**CITY OF OREGON  
OREGON, OHIO  
WATER TREATMENT PLANT – CONCRETE REPLACEMENT PROJECT**

**Addendum No. 2  
May 8, 2024**

To: Prospective Bidders  
From: **ARCADIS U.S., Inc.**  
**One Seagate, Suite 700**  
**Toledo, Ohio 43604**  
Owner: **City of Oregon**  
**Department of Public Service**  
**5330 Seaman Road**  
**Oregon, Ohio 43616**  
Subject: **Water Treatment Plant – Concrete Replacement Project**

DRAWING NO.: S03-03

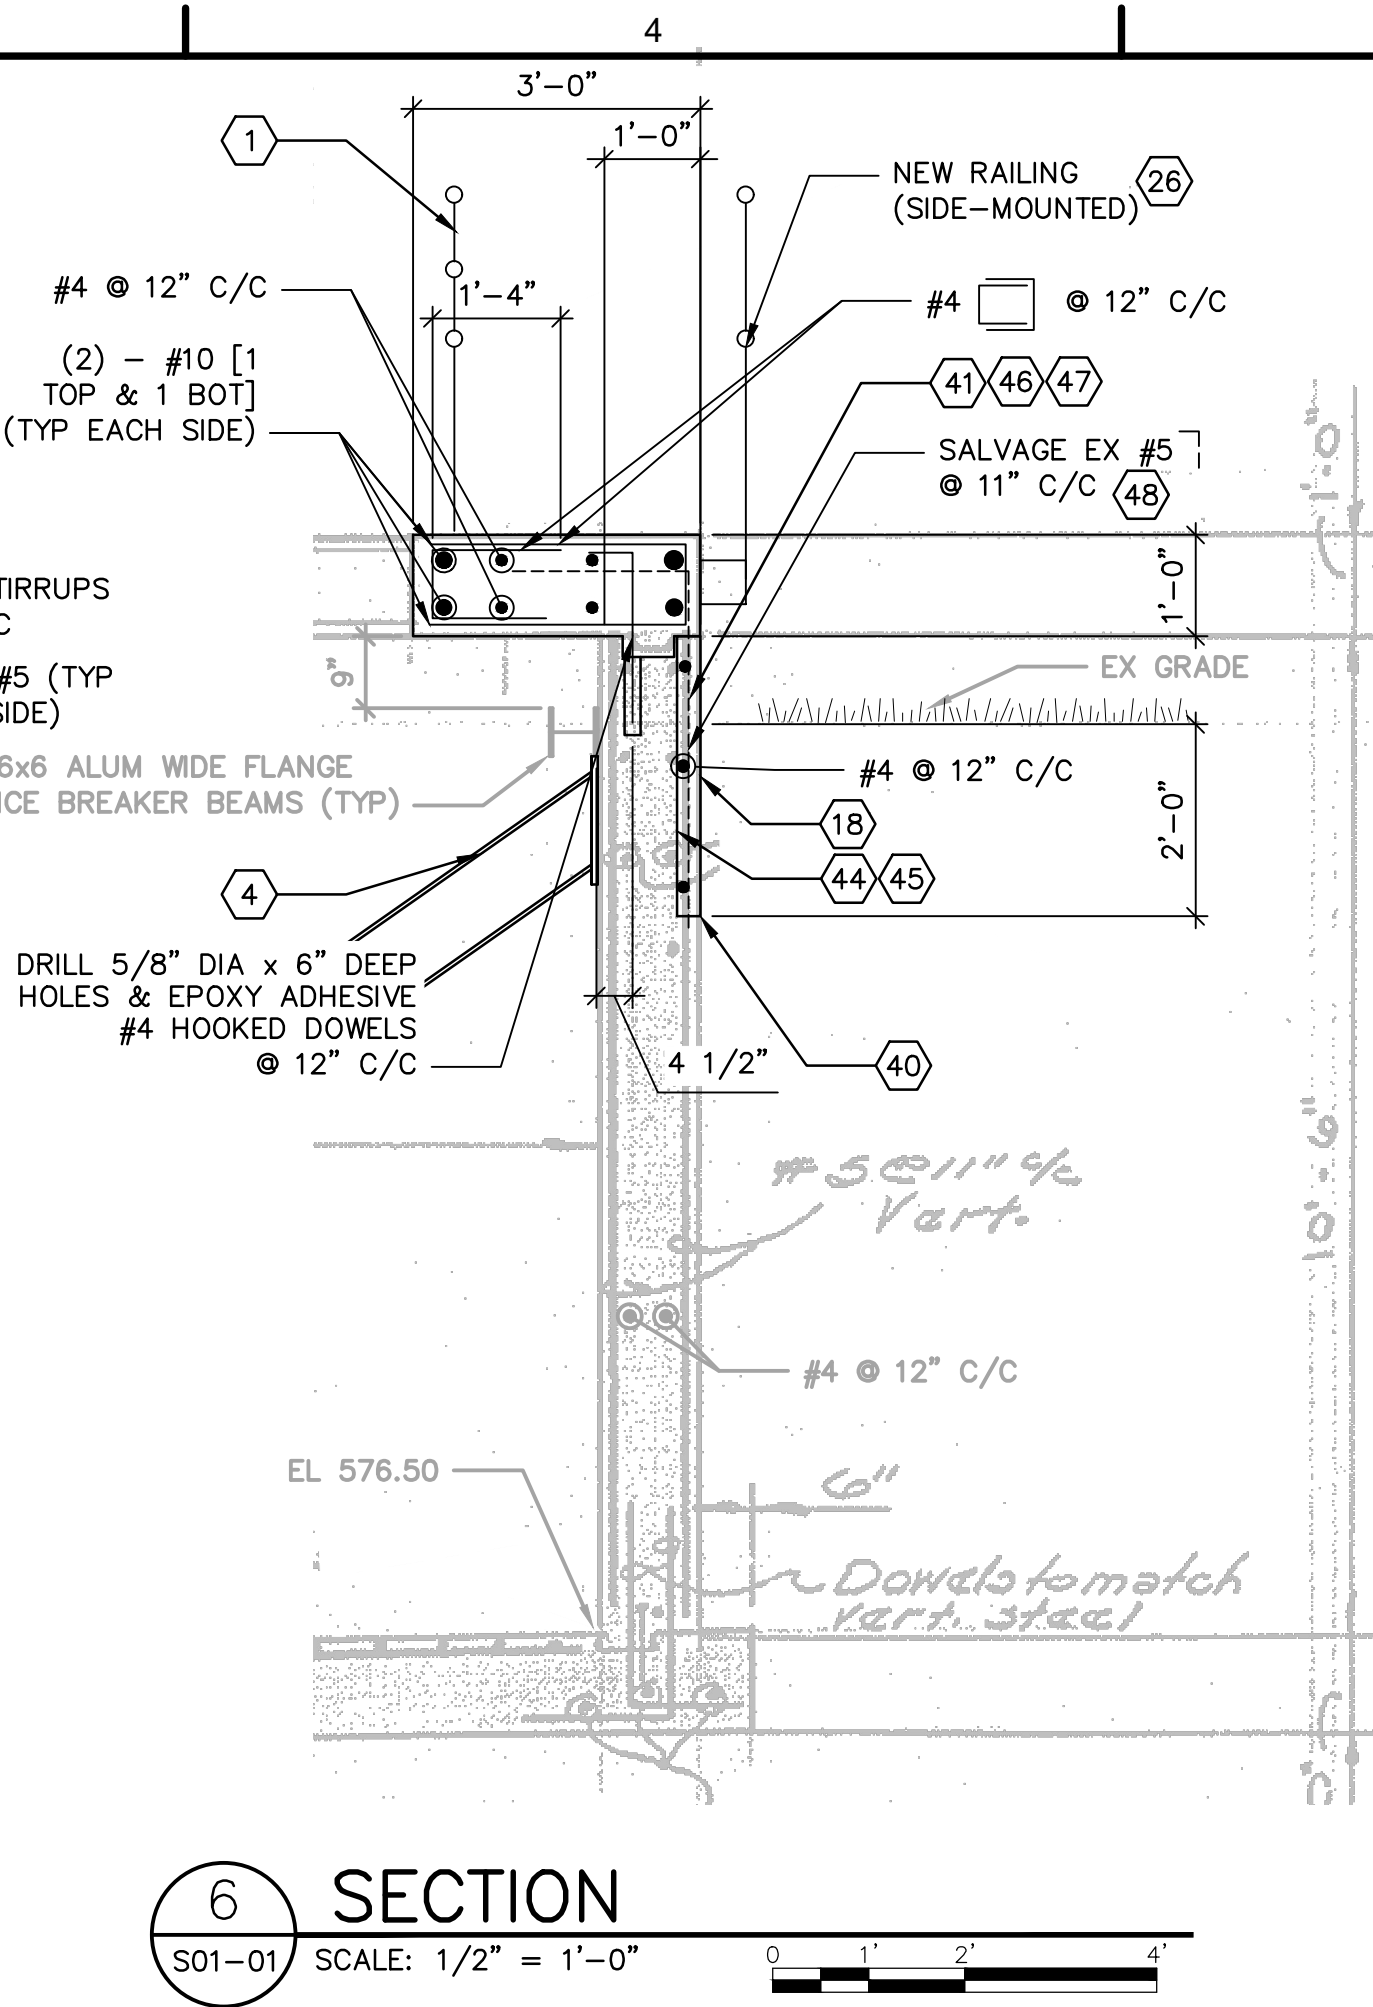
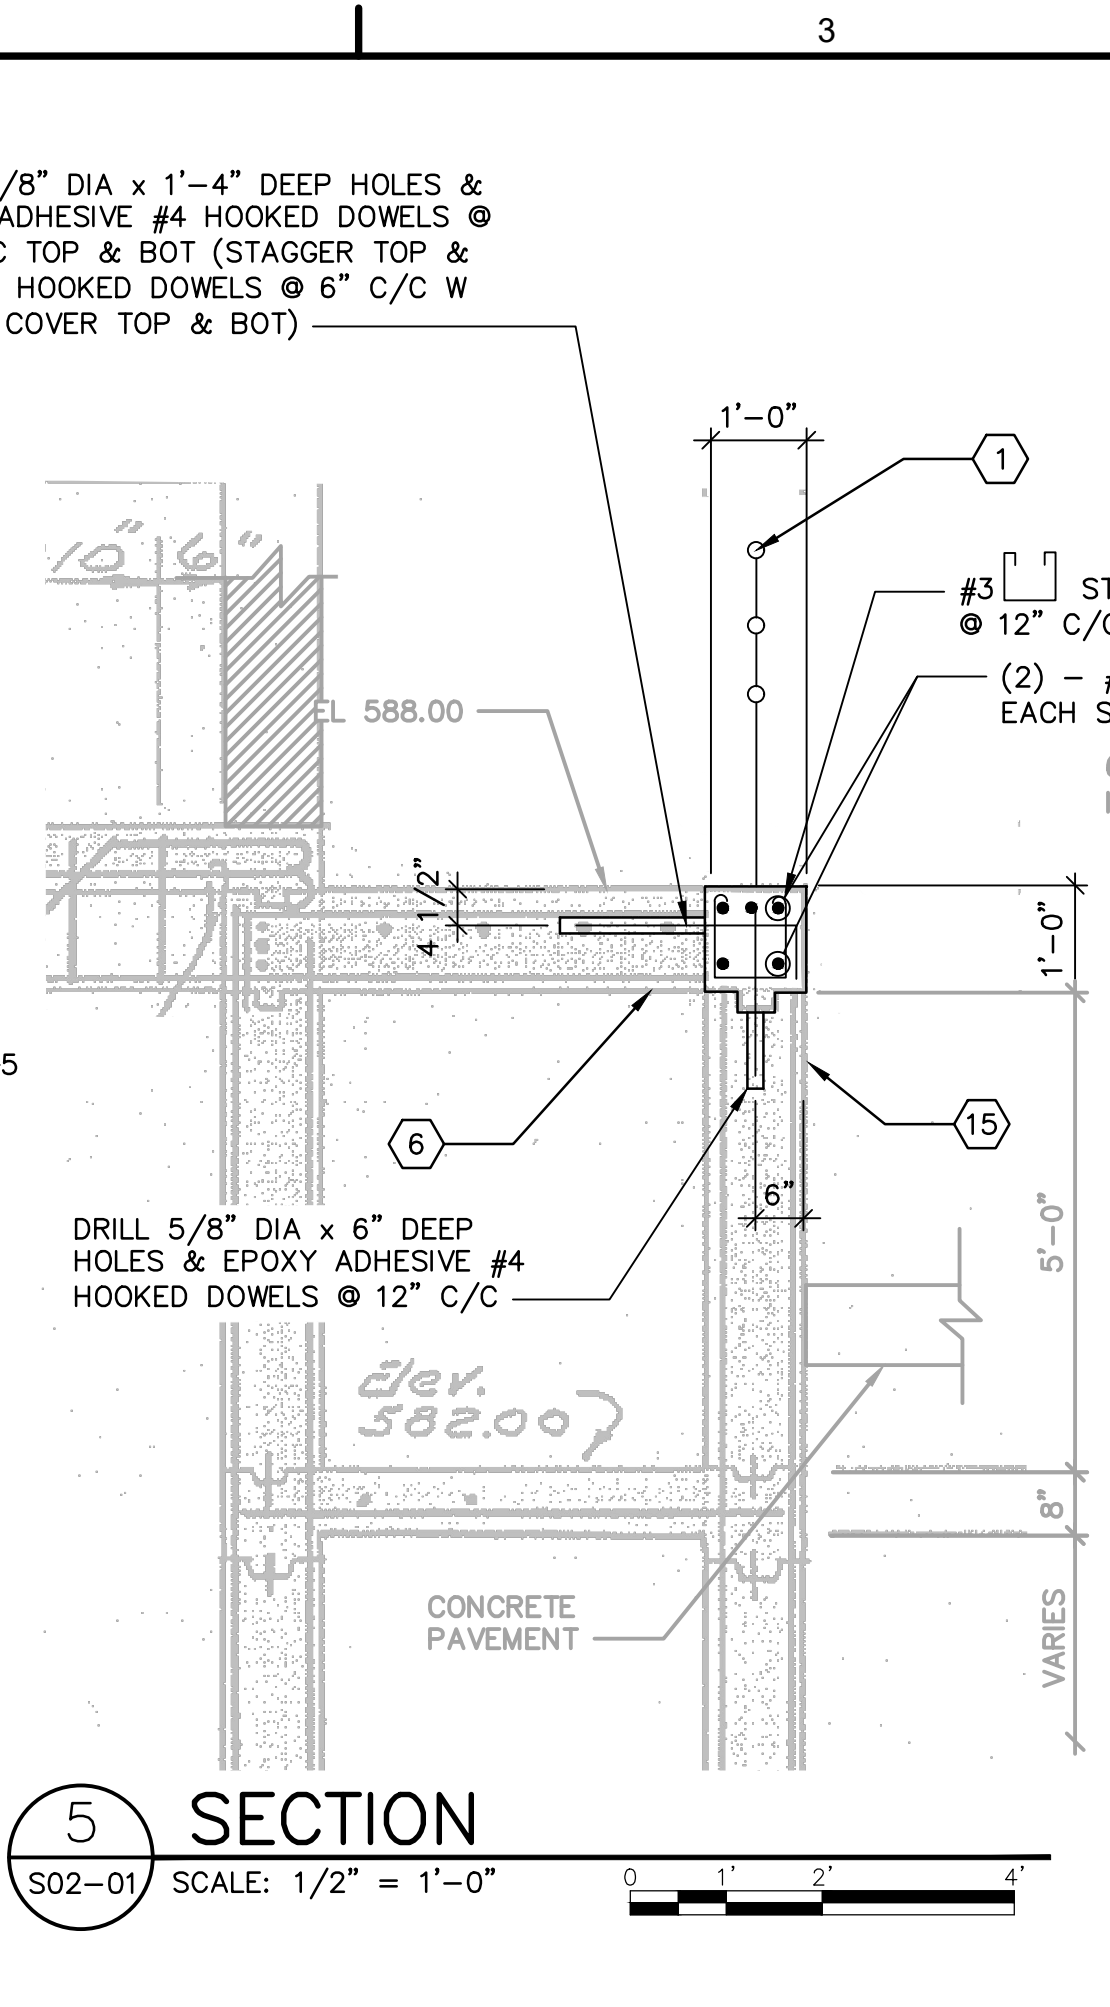
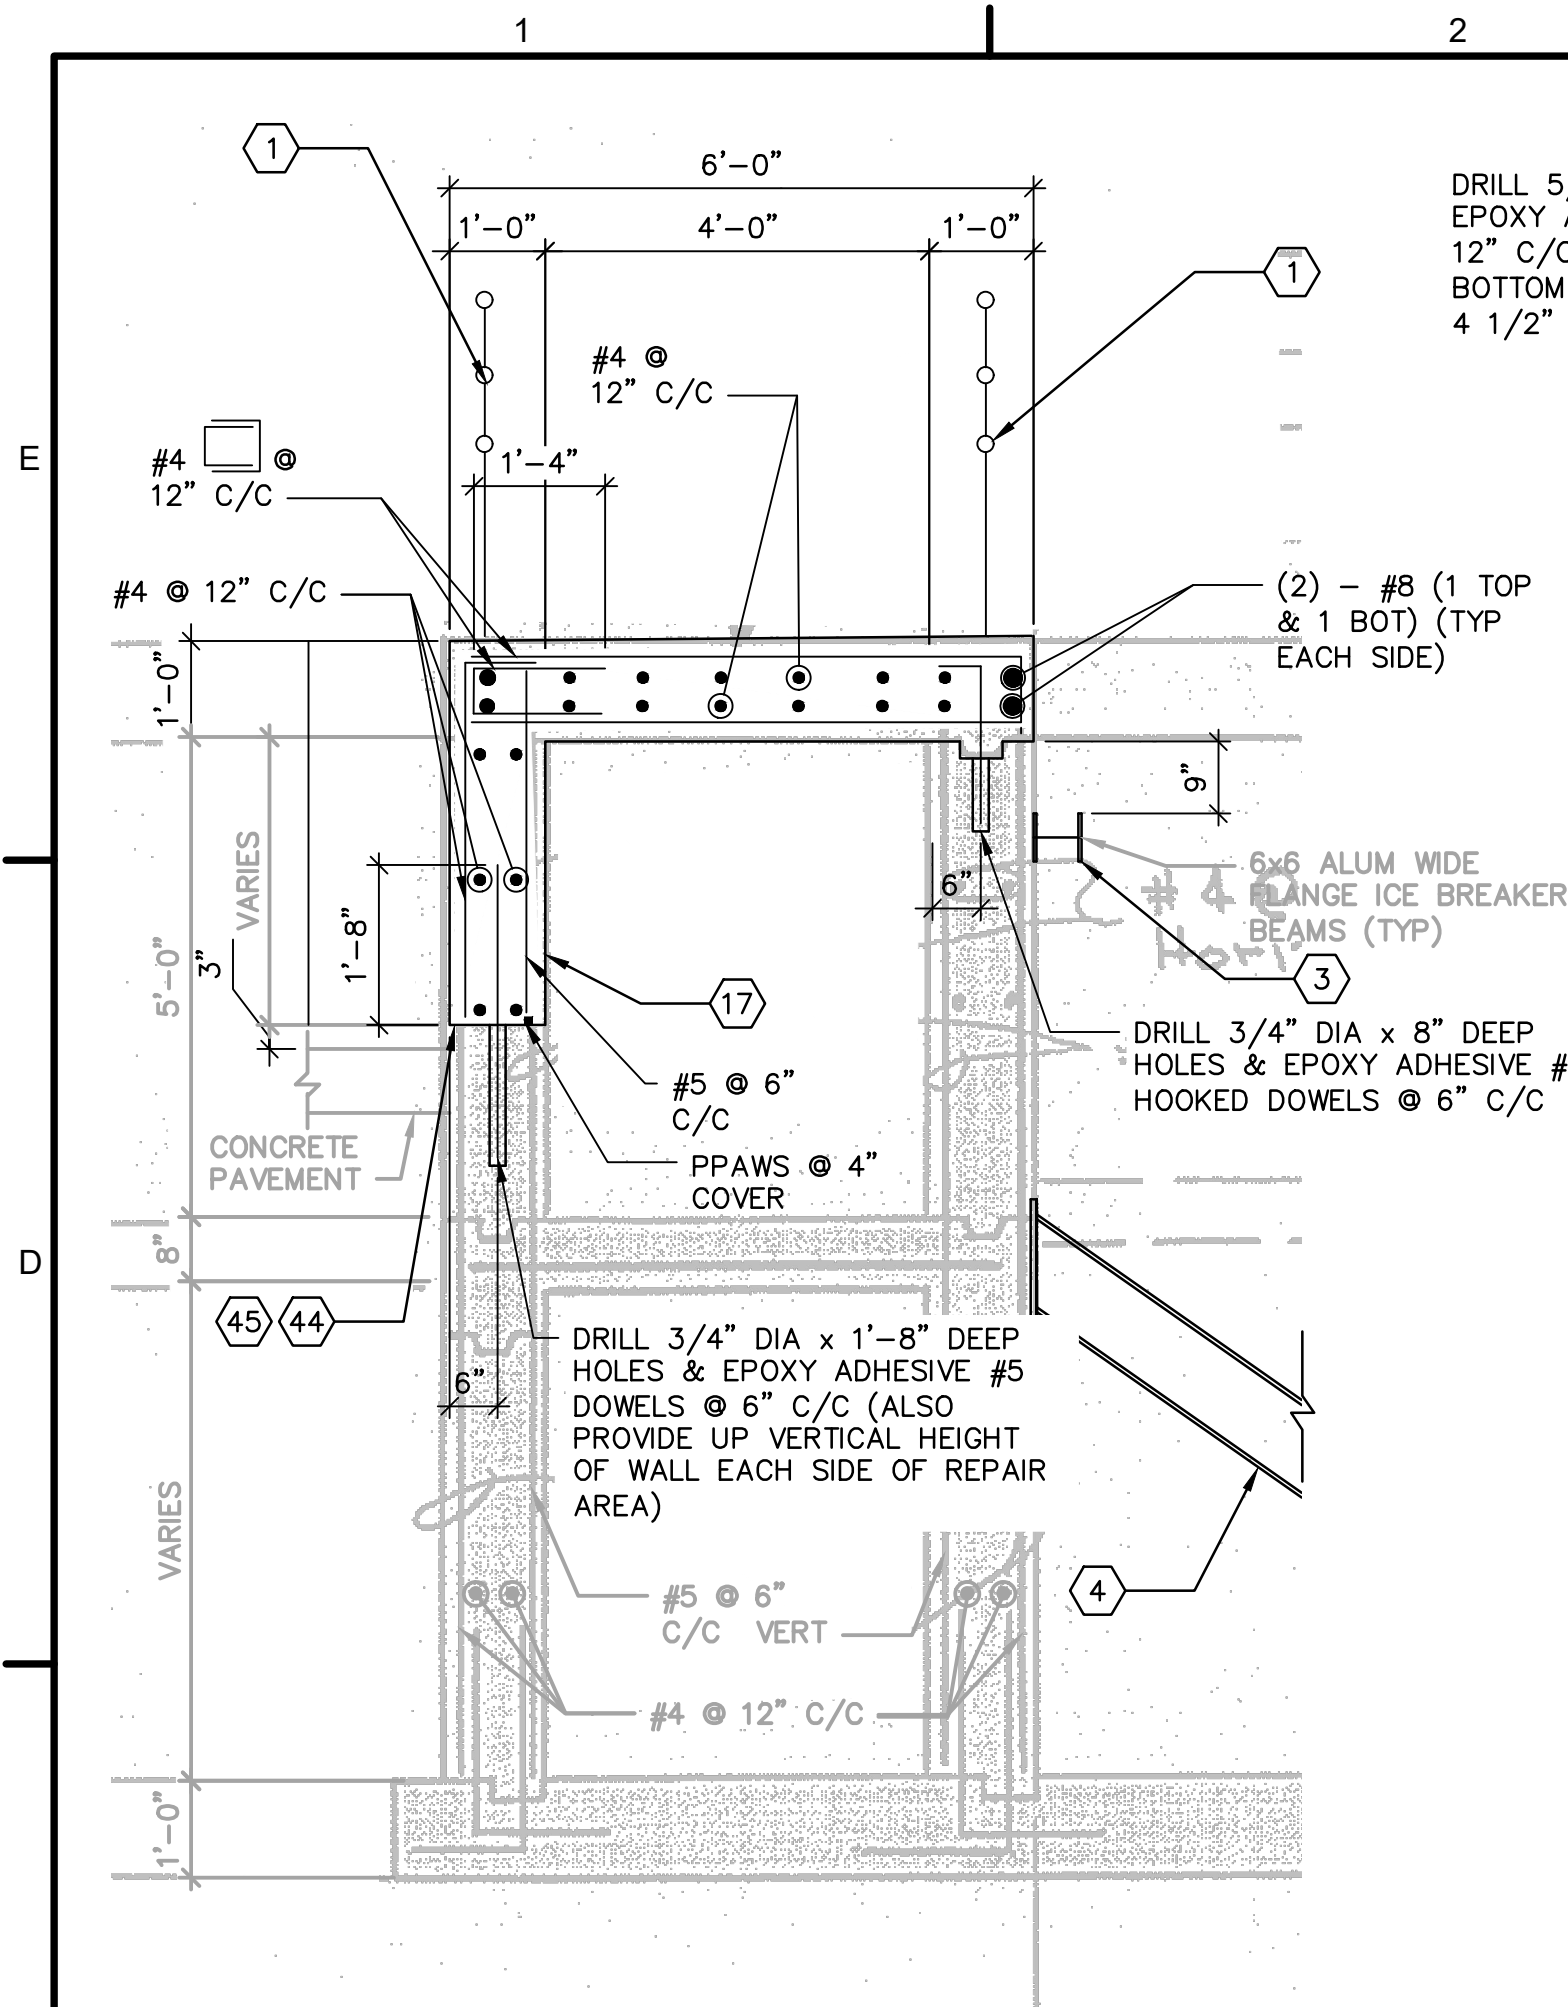
- 1.22 Drawing S03-03, RECARBONATION BASINS (NORTH) – TOP PLAN - REINFORCING - Delete this sheet in its entirety and substitute revised Drawing S03-03, included with this Addendum No. 2.

7. The scale for drawing S03-03 is listed as 3/16" = 1'-0". There are (12) annotated dimensions that do NOT scale correctly. See attached mark-up showing dimensions that do NOT scale correctly.
- a. Can you please advise what these dimensions should be?

Response: *Some of the specific dimensions referenced by the contractor are correct but not drawn to scale and some of the dimensions referenced are to scale. This drawing has been revised and re-issued in Addendum No. 2 to provide clarity to this issue.*

27'-9" - DIMENSIONS WITH BOXES AROUND THEM IN PLAN ARE CORRECT BUT NOT DRAWN TO SCALE. THESE SAME DIMENSIONS WITH BOXES ALSO APPLY TO SHEETS S03-04 AND D03-02.
